Mt. Hope High School
Bristol, RI
Pare Project No. 23099.01

February 11, 2025
Page 1 of 8

**RESPONSES TO BETA PRELIMINARY PLAN PEER REVIEW COMMENTS DATED
JANUARY 24, 2025**

DRAWING NO.: C6.5
SHEET NO. 45 OF 152

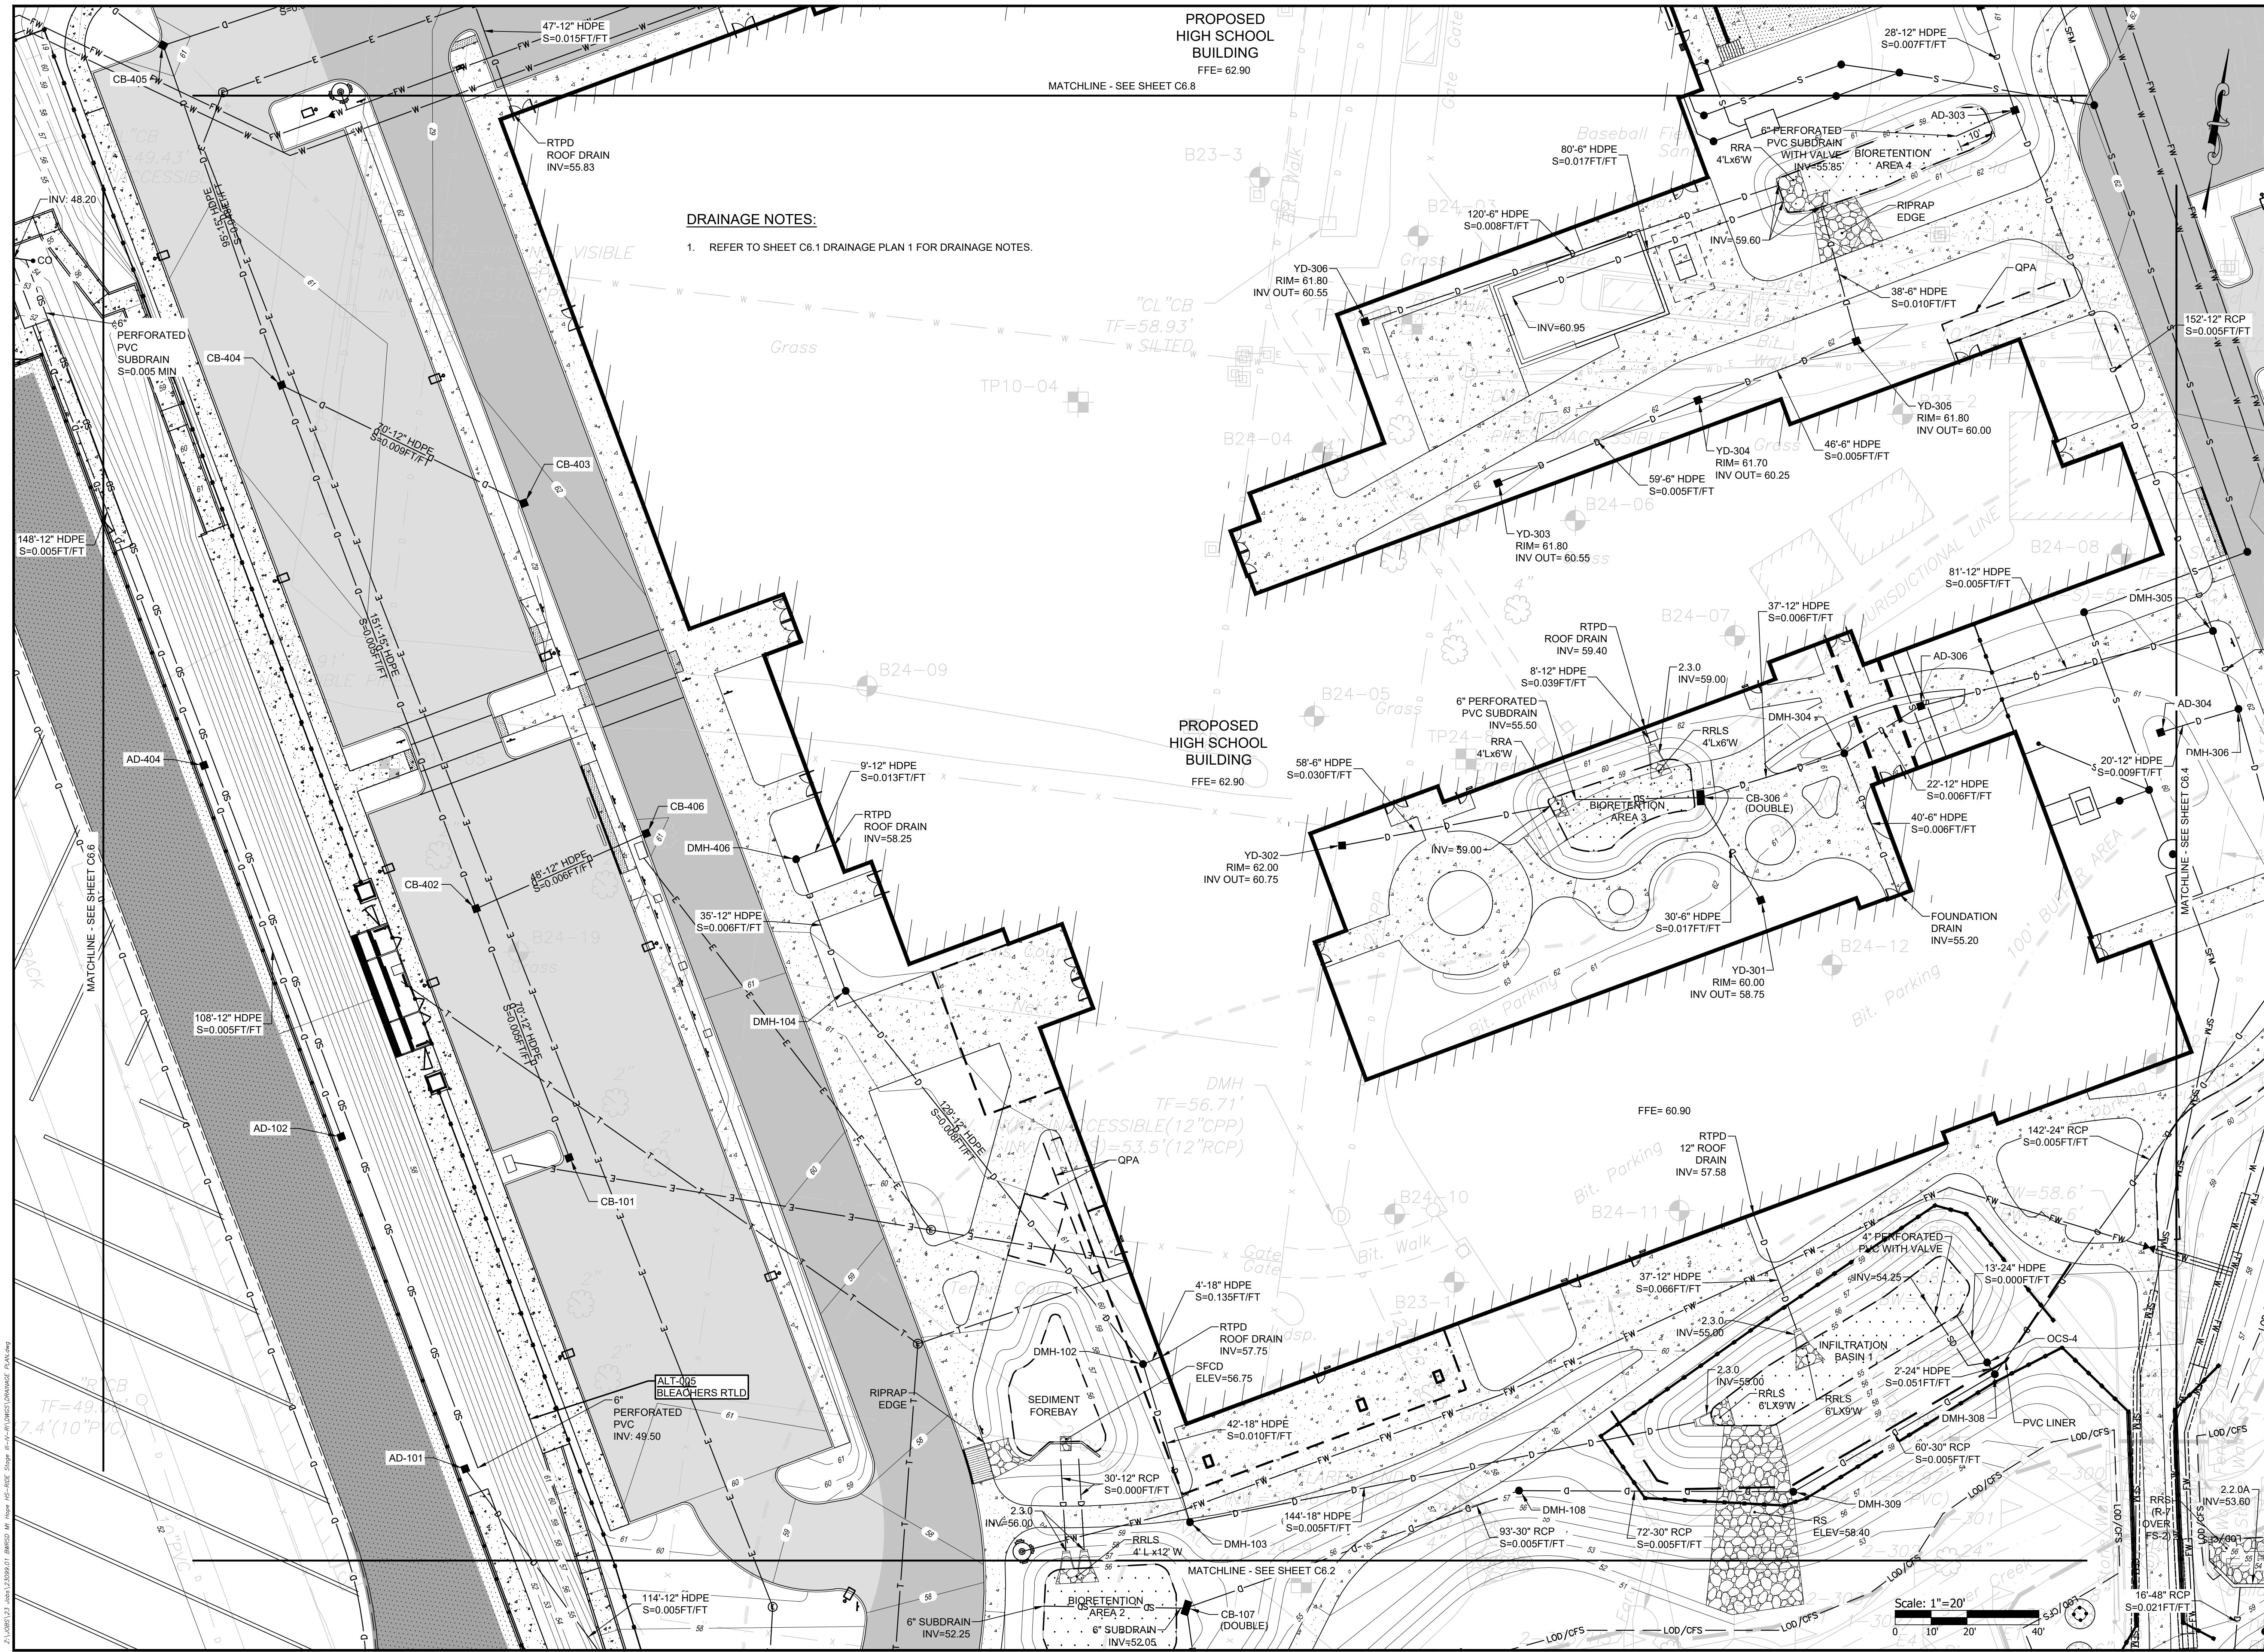
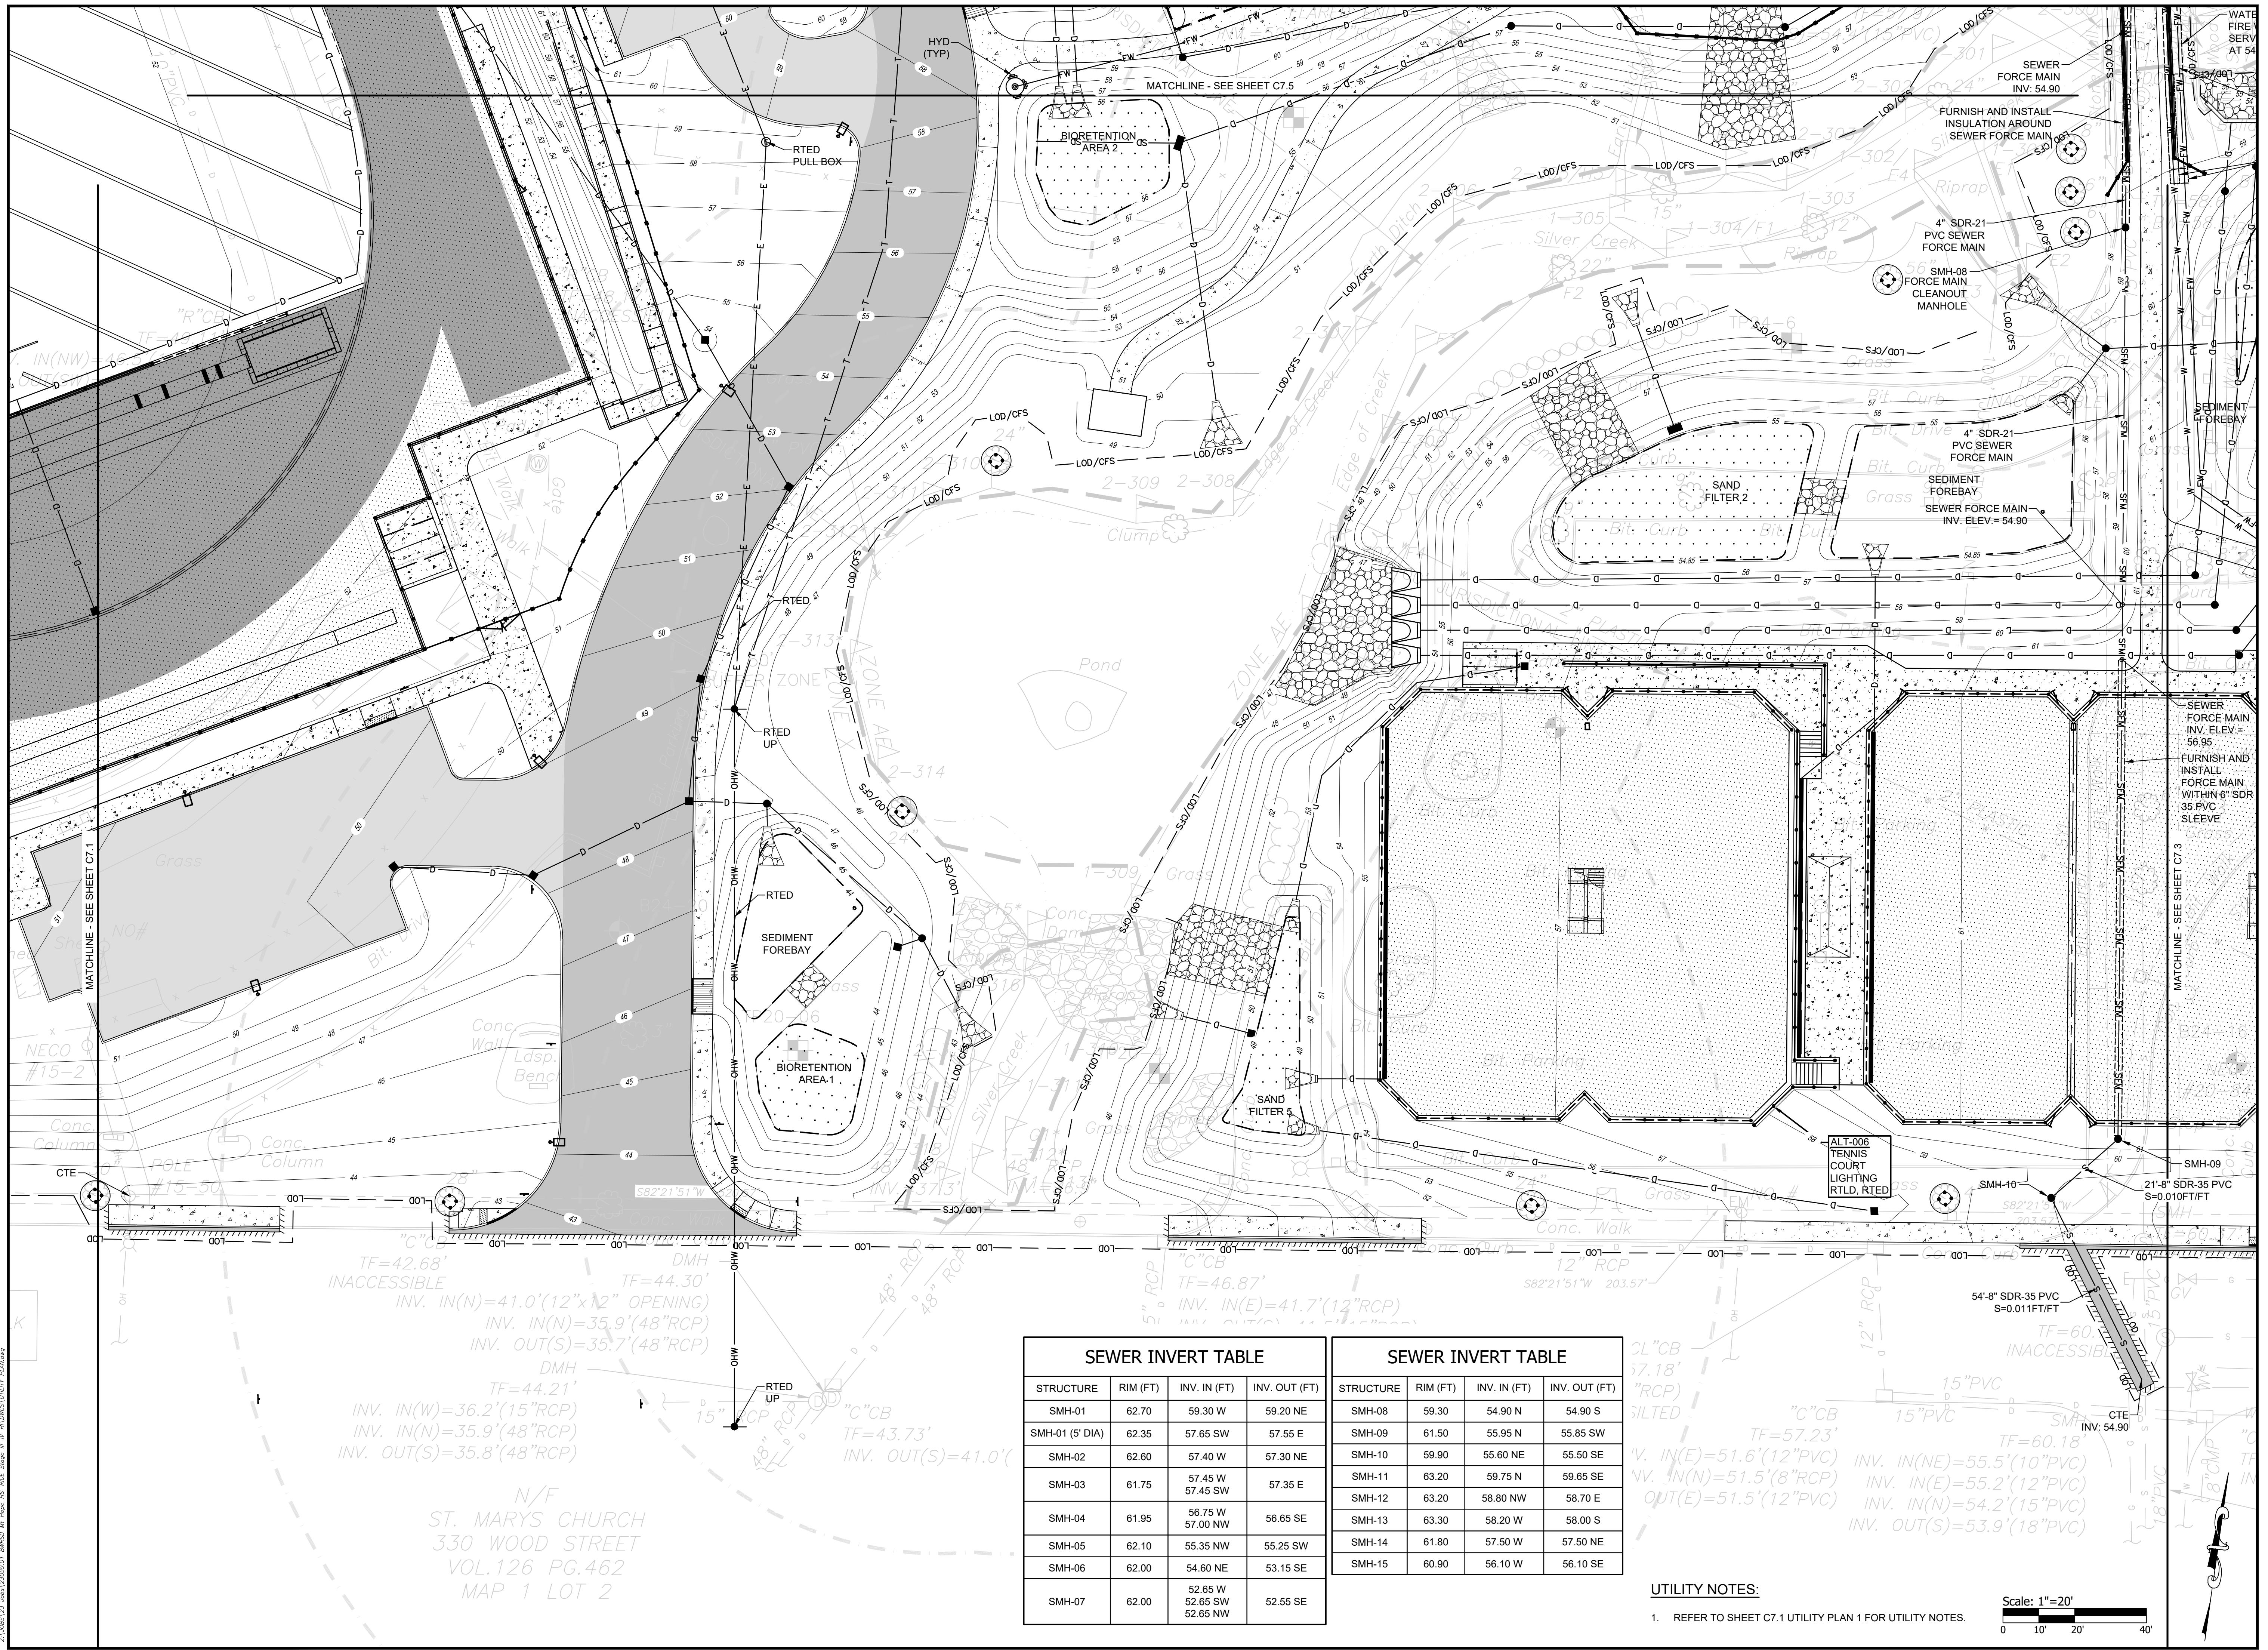
- **COMMENT:** Bioretention Area 4 is shown having an underdrain, the underdrain is not included as an outlet in the HydroCAD model, please review.
RESPONSE: Bioretention Area 4 has been revised to provide 10 feet of perforated PVC with a valve for maintenance purposes. The valve shall remain closed to allow for exfiltration. Please refer to plan sheet C6.5 for revisions.
